MONTGOMERY COUNTY HISTORIC PRESERVATION COMMISSION
STAFF REPORT

Address:	7118 Cedar Ave., Takoma Park	Meeting Date:	5/12/2021
Resource:	Contributing Resource Takoma Park Historic District	Report Date:	5/5/2021
Applicant:	Laura Welch Ben Norkin, Architect	Public Notice:	4/28/2021
Review:	HAWP	Tax Credit:	n/a
Permit No.:	949652	Staff:	Dan Bruechert
Proposal:	New Screened Porch, Other Minor Alterations, Rear Addition

SHEET NAME:
**EXISTING
CONDITIONS**

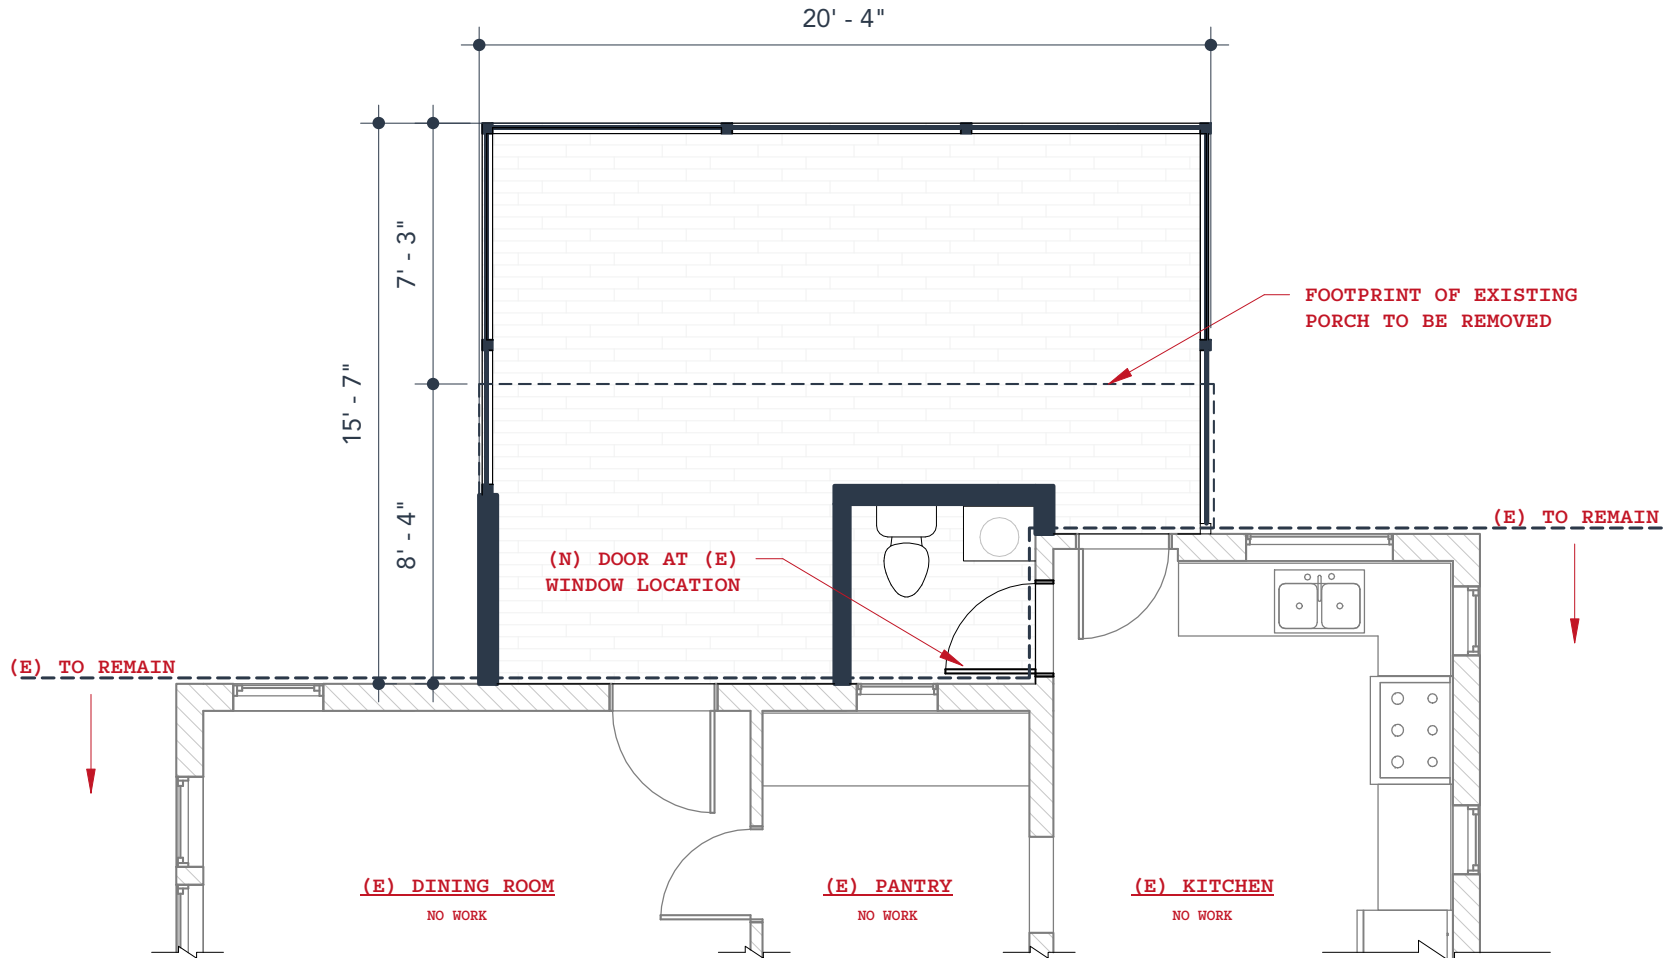
At the rear of the subject property, there is a rectangular screened-in porch, with a flat roof that measures approximately 20' × 8' (twenty feet by eight feet). The basement level of the porch is parged concrete, and the remainder of the porch is wood framed. The applicant proposes to demolish the existing porch, while retaining the existing basement projection. Staff finds the existing rear porch is not historic and does not add to the historic character of the house or surrounding district and recommends the HPC approve the porch demolition.

SHEET NAME:
FLOOR PLAN

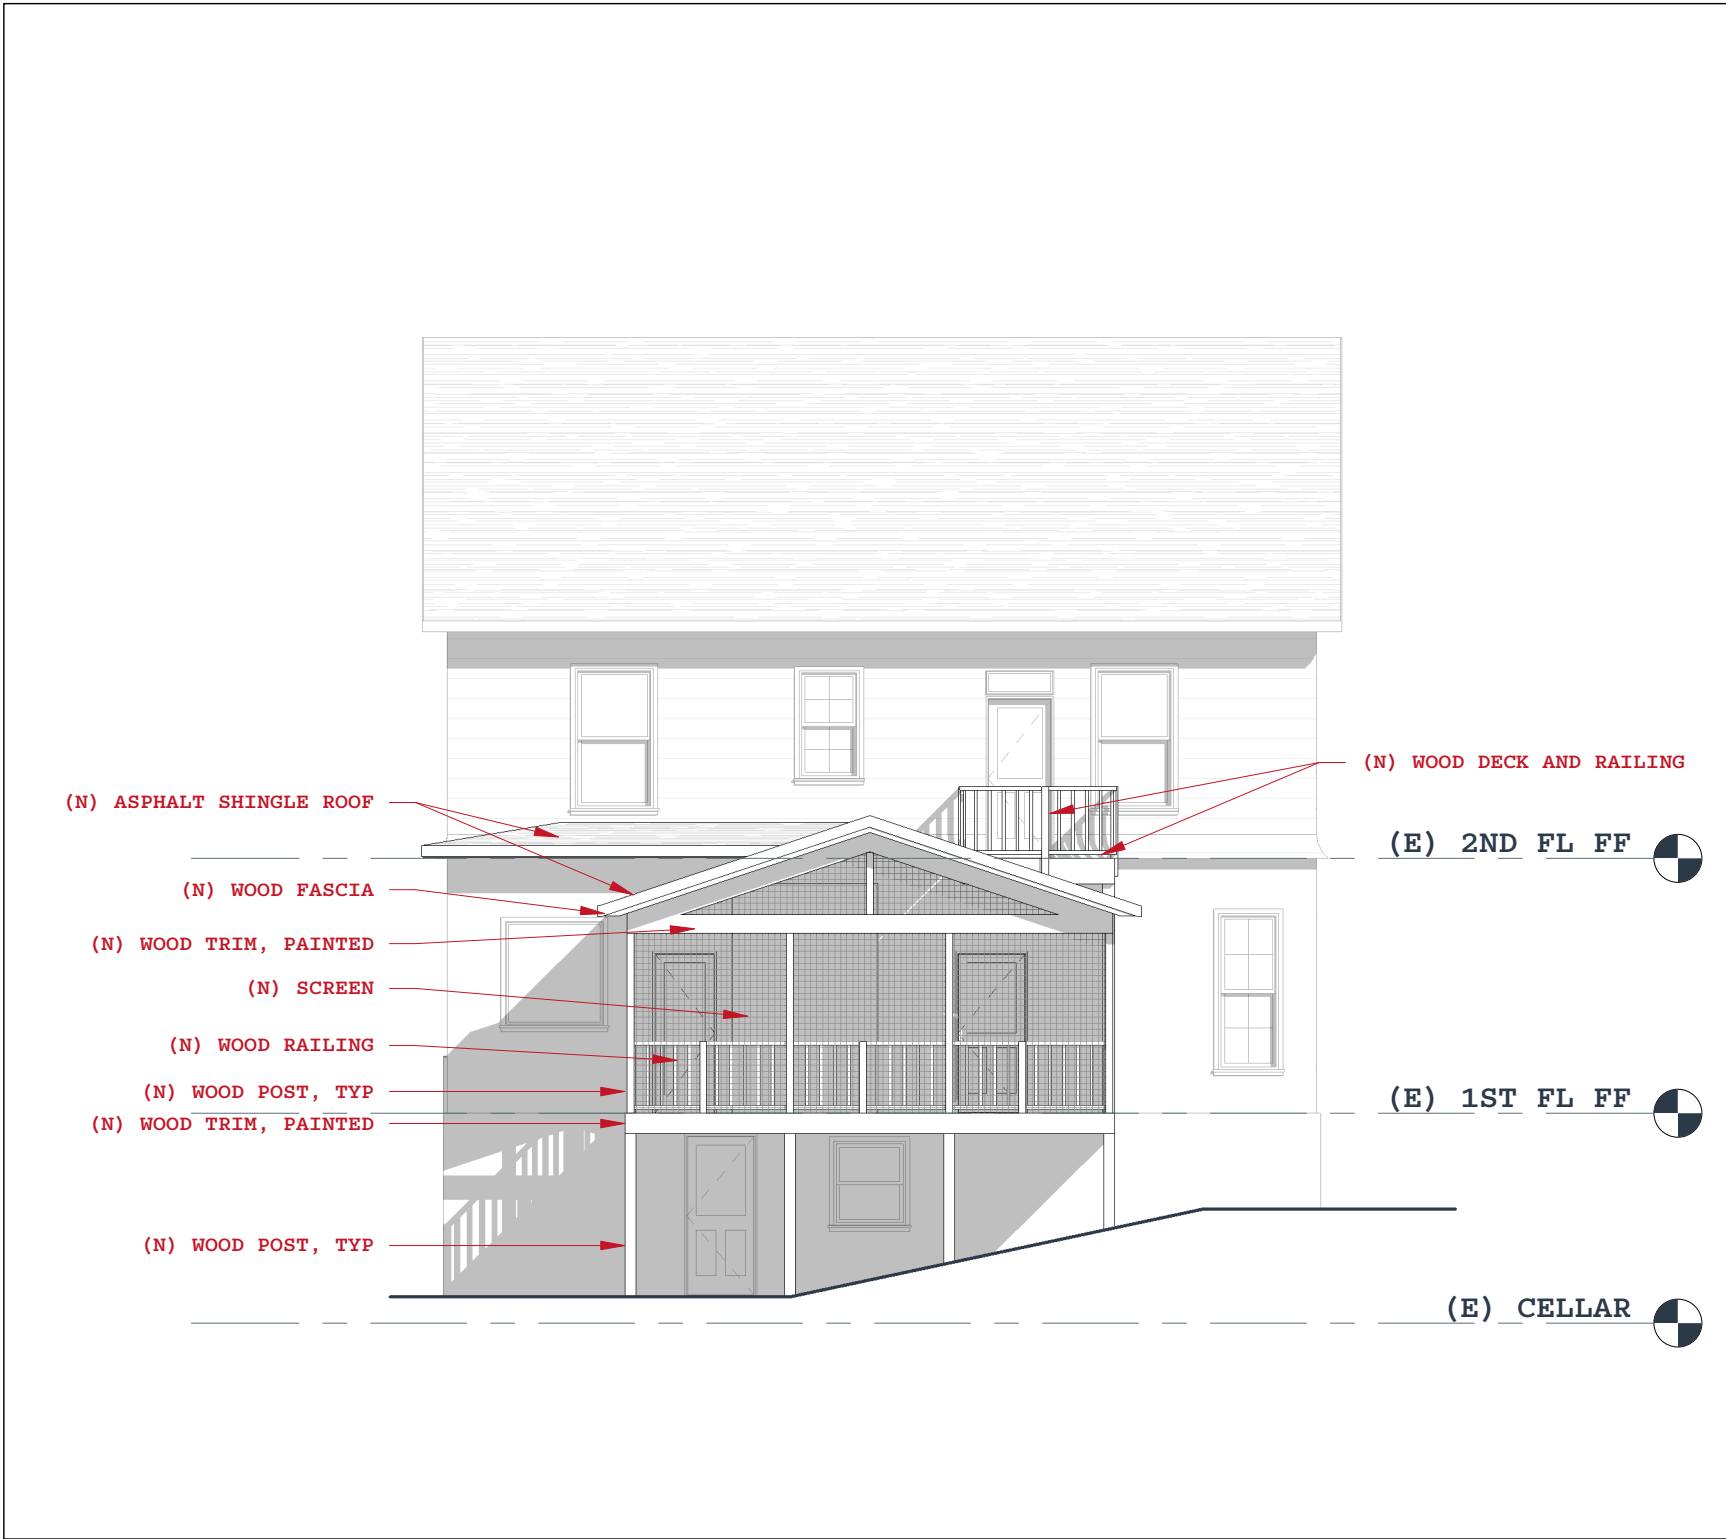
In place of the existing porch, the applicant proposes to construct a larger porch, measuring 15' 7" × 20' 4" (fifteen feet, seven inches by twenty feet, four inches) with a rear-facing gable roof. The porch will be supported by square wood posts. The porch structure will be wood and the roof will be asphalt to match the existing house. There are no exterior stairs included in the proposal. In the southwest corner of the porch, the applicant proposes to install a fiber cement wall panel, which due to its location, will not be seen from the public right-of-way. Staff finds the design and materials for the proposed porch are compatible with the house and surrounding district. Staff additionally finds that the enlarged size of the porch will not have a significant impact on the character of the house and is not out of scale with the surrounding district.

At the rear of the house, the applicant proposes to construct a new half-bathroom, accessed from the interior of the house. The bathroom measures approximately 5' × 5' (five feet square). There are no exterior windows proposed for the bathroom. Exterior material specifications for the bathroom addition are not shown on the application, but the architect has informed Staff that the proposal is to install smooth fiber cement panels. Staff finds the size and scale of the proposed bathroom are so small that it likely will not have a visual impact from the public right-of-way. Additionally, this room will be inside the screened-in porch, so its visibility will be further reduced. Staff finds that smooth fiber cement, like on the panel discussed above is an appropriate material.

On the second floor, above the screened-in porch, the applicant proposes constructing a small "widow's peak" (Staff has also heard this called a widow's watch) wood deck and railing. This feature will not be visible from the public right-of-way and should be approved as a matter of course, per the *Design Guidelines*.

**PROPOSED
ELEVATION**

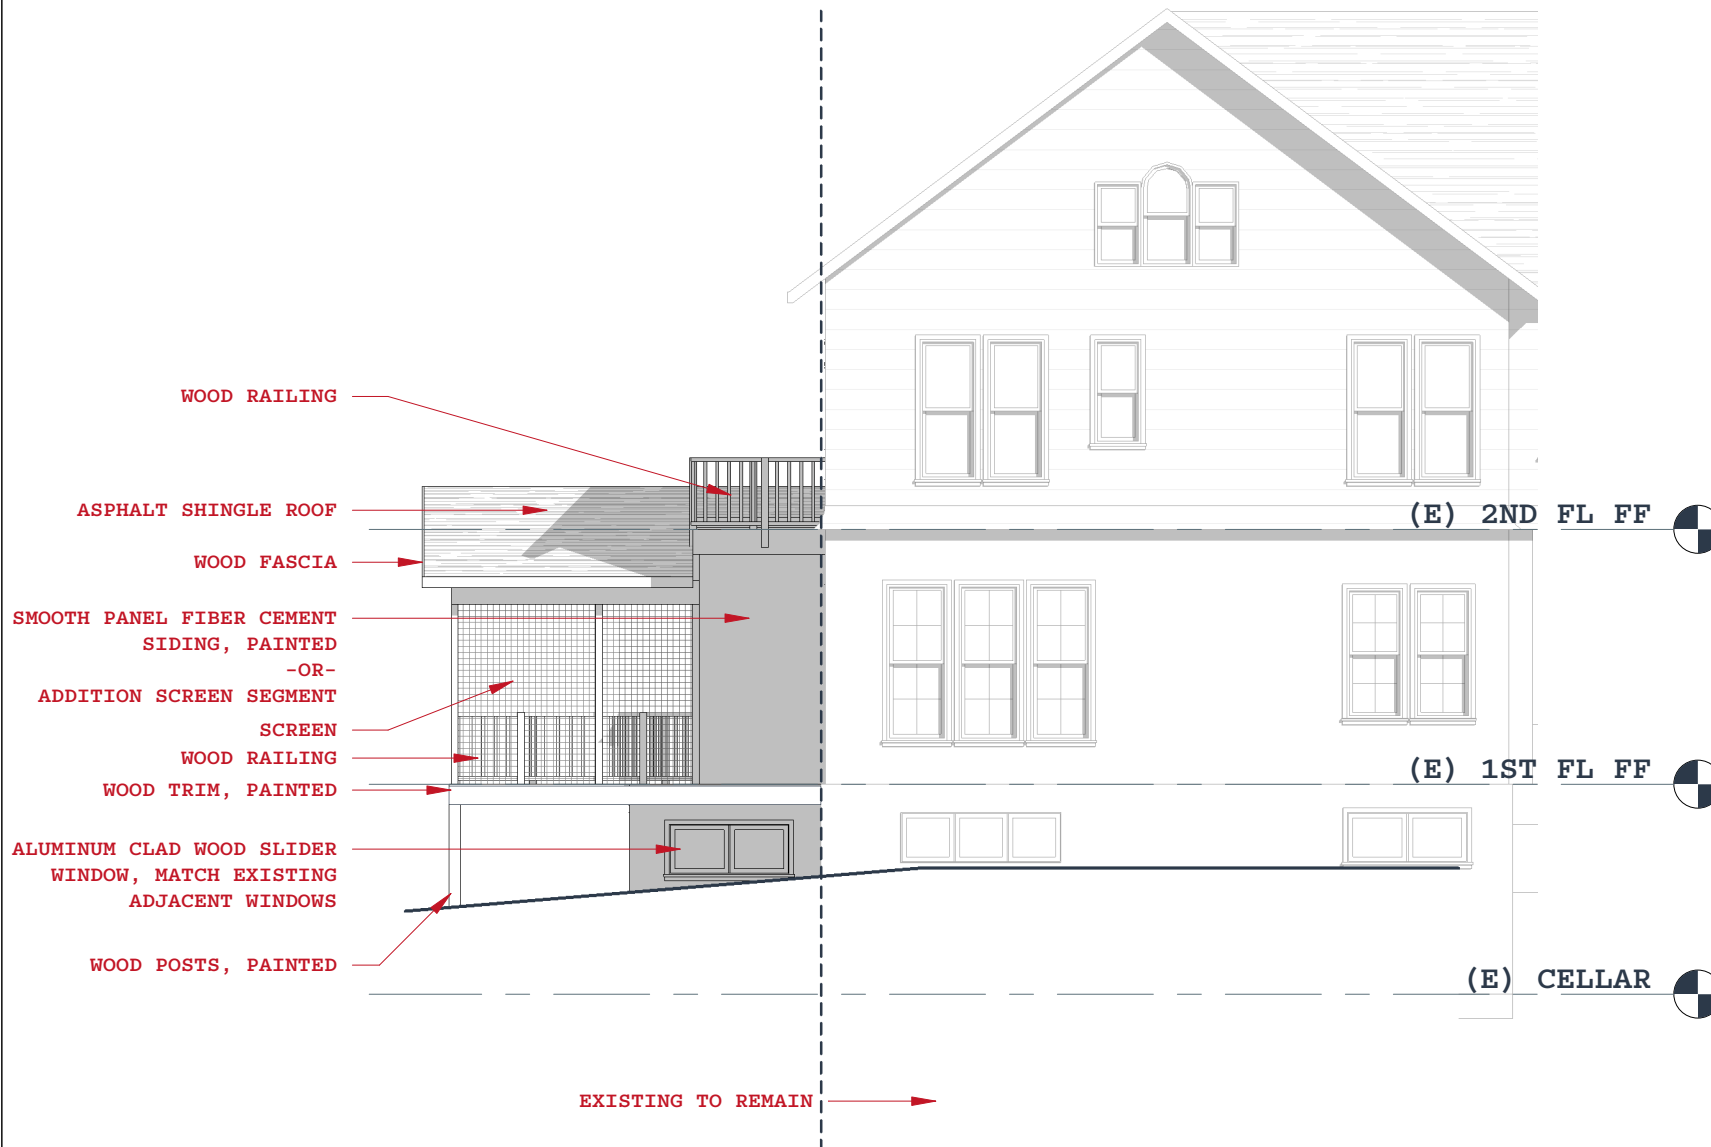
The last proposed change is the installation of a new aluminum-clad wood, slider window in the basement level on the west elevation. Aluminum-clad wood windows are generally acceptable on Contributing Resources in new construction in the Takoma Park Historic District. Additionally, this window is not visible from the public right-of-way and should be approved as a matter of course.
